# Detailed Site Plan

## Popeyes

# DSP-19031-02

SUBJECT: Detailed Site Plan DSP-19031-02  
Alternative Compliance AC-24001  
Type 2 Tree Conservation Plan TCP2-026-2018-02  
Popeyes

Figure 2: Detailed Site Plan

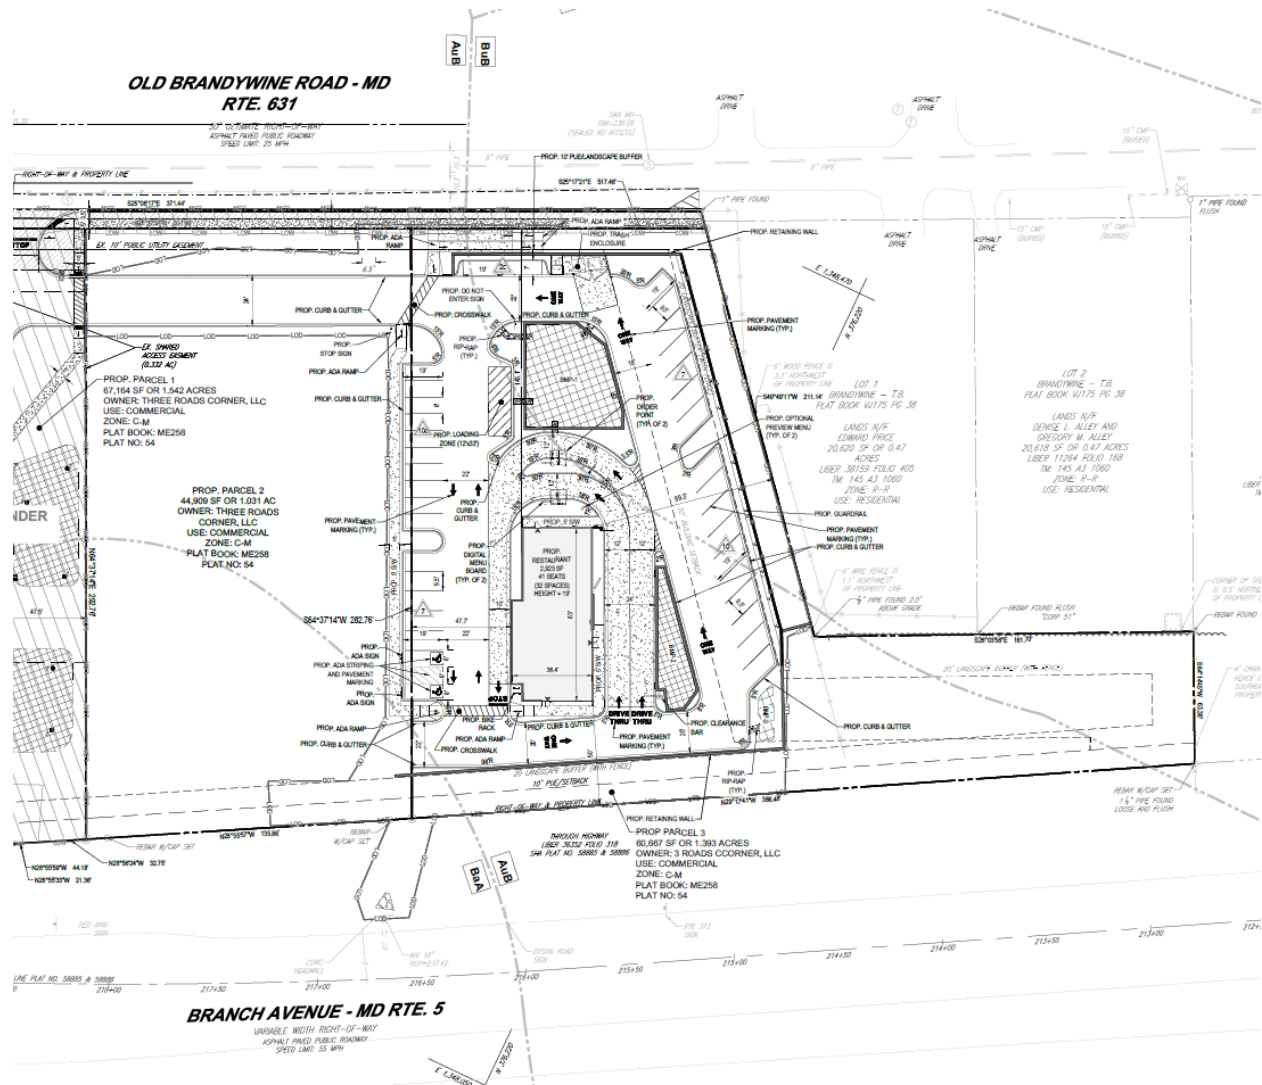
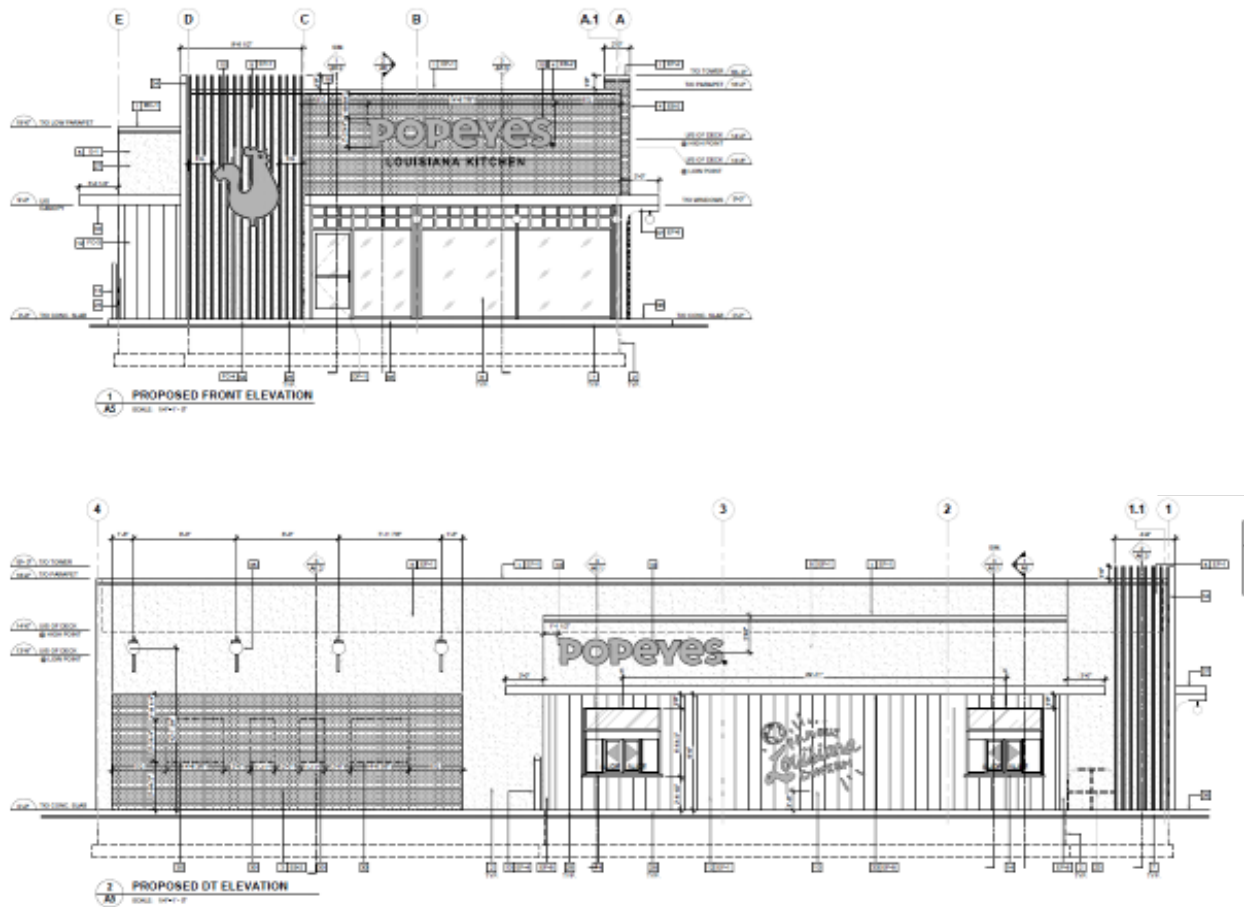
Notes: Regarding the parking setback requirements shown on the submitted plan, a condition is included herein requiring the applicant to clarify which zoning ordinance is being referred to and, if not, remove this information from the plan. Another condition is also included requiring the applicant to correct “front setback” to “street setback”.

\*\*A condition is included herein requiring the applicant to revise the dimension of the provided southern setback, to be consistent with what is shown on the plan.

\*\*A condition is included herein requiring the applicant to properly label the dimensions of 60-degree nonparallel parking spaces.

\*\*\*There are two parallel parking spaces shown on the plan. A condition is included herein requiring the applicant to revise the parking schedule.

The subject DSP includes both building-mounted and pole-mounted lighting throughout the site, with details. Staff find that the submitted photometric plan shows adequate lighting for users on-site and is sufficient for illuminating drive aisles, building entryways, and walking paths. A condition is included herein requiring the applicant to add a note indicating that all light fixtures included in this DSP are fully cut-off and directed downward to reduce glare and light spill-over. For people to access the proposed development on Parcel 3, they need to use the shared vehicular entry/exit point located on Parcel 1 and cross Parcel 2, via a drive aisle. Conditions are included herein requiring the applicant to revise the photometric plan, submitted for this DSP, to cover the entire access route from MD 631 and add additional pole-mounted light fixtures along the route on Parcel 2, to ensure sufficient illumination.

The subject DSP includes one loading space, located internally to the subject property. With the planting along the MD 631 frontage, public view to the loading space is screened. A condition is included herein requiring the applicant to revise the landscape plan to accommodate the provision of the one loading space. The submitted plans also show the location of the proposed dumpster. Details of the dumpster enclosure are included in this DSP but are blurred. Conditions are included herein requiring the applicant to provide legible dumpster details and revise the large-scale plan for the proposed dumpster, to be consistent with the design shown on other plans.

- k. On Sheet C-301, label the area of the proposed building on Parcel 1 that was approved under DSP-19031.
- l. Clarify which Zoning Ordinance contains the parking setback requirements and, if not required, remove this information from the plans.

- m. Revise the dimension of the provided southern setback to be consistent with what is shown on the plan
- n. Accurately label the dimensions of 60-degree nonparallel parking spaces.

- o. Revise the parking schedule to include two parallel parking spaces provided.
- p. Organize information and details related to the drive-through service in one package.

- (2) Revise the photometric plan, submitted for this DSP, to cover the entire access route from MD 631 (Old Brandywine Road).
    - (3) Add additional pole-mounted light fixture along the route on Parcel 2 to ensure sufficient illumination.

- t. Regarding the proposed dumpster:
    - (1) Provide legible dumpster details.
    - (2) Revise the large-scale plan for the proposed dumpster to be consistent with the design shown on other plans
